Docket Number:	03-AFC-02C
Project Title:	Los Esteros Phase II Compliance
TN #:	224870
Document Title:	Los Esteros Critical Energy Facility Responses to Staff's Data Requests, Set 1, A1 through A23
Description:	N/A
Filer:	Eric Janssen
Organization:	Ellison Schneider Harris & Donlan LLP
Submitter Role:	Applicant Representative
Submission Date:	10/2/2018 4:53:30 PM
Docketed Date:	10/2/2018

LOS ESTEROS CRITICAL ENERGY FACILITY, LLC

RE: Docket No. 03-AFC-02C: Petition for Modification
Responses to Staff's Data Requests, Set 1, A1 through A23

ATTACHMENT DRA10
TYPICAL VANADIUM FLOW CONTAINMENT DRAWING

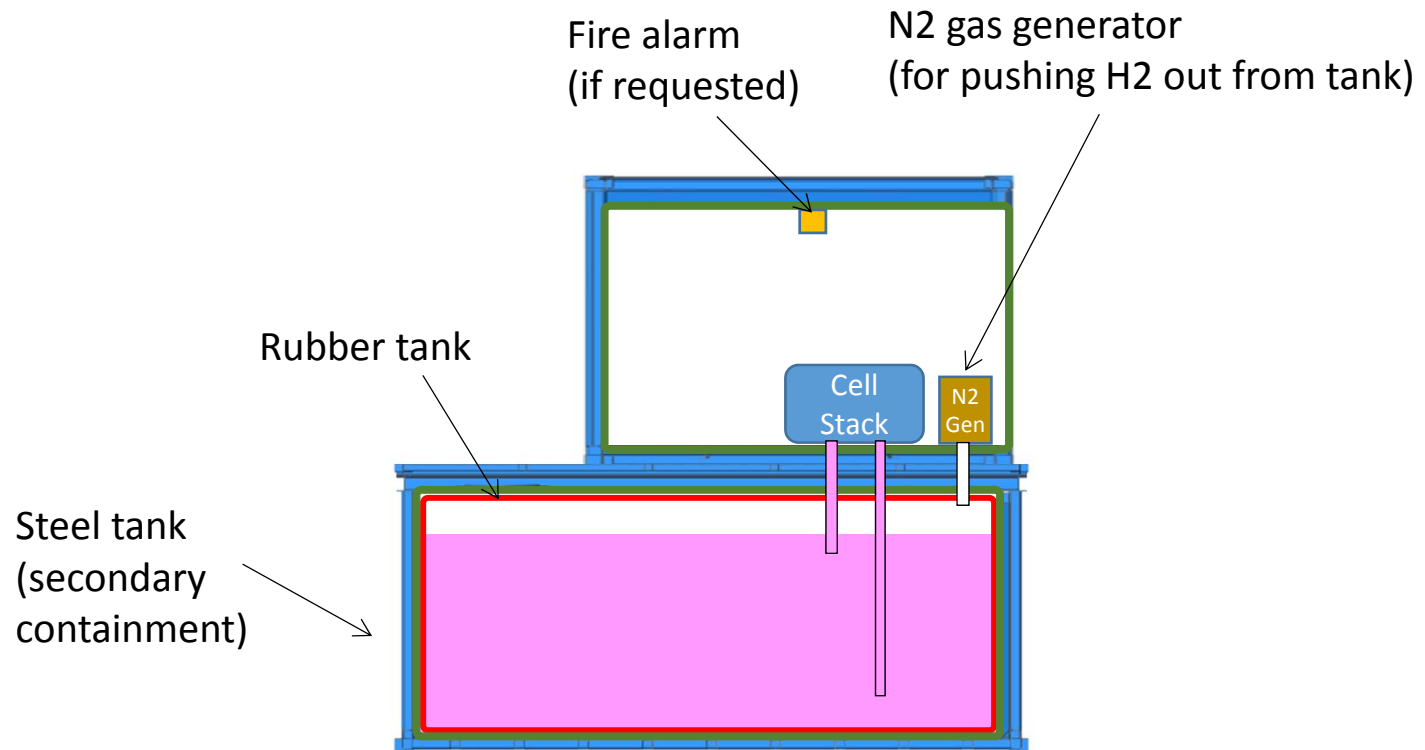
- A10. Please provide any preliminary drawings that show outline of the vanadium redox flow battery installation with the secondary containment.

- A21. Please provide preliminary drawings of the vanadium redox flow battery installation showing the location of the hydrogen purge and the location of the fire alarm or alarms.

RESPONSE: Please refer to Attachment DRA10, "Typical Vanadium Flow Containment Drawing".

RESPONSE: Please see page 2 of attachment DRA10. If a fire alarm is required, it will be placed in the battery cell container as identified in the drawing. A small amount of hydrogen gas is generated in the cell stacks as a side reaction, and flows to the electrolyte tanks. In the event of an emergency, nitrogen gas is generated by nitrogen gas generators and flows to the tank to push the hydrogen gas to the atmosphere.
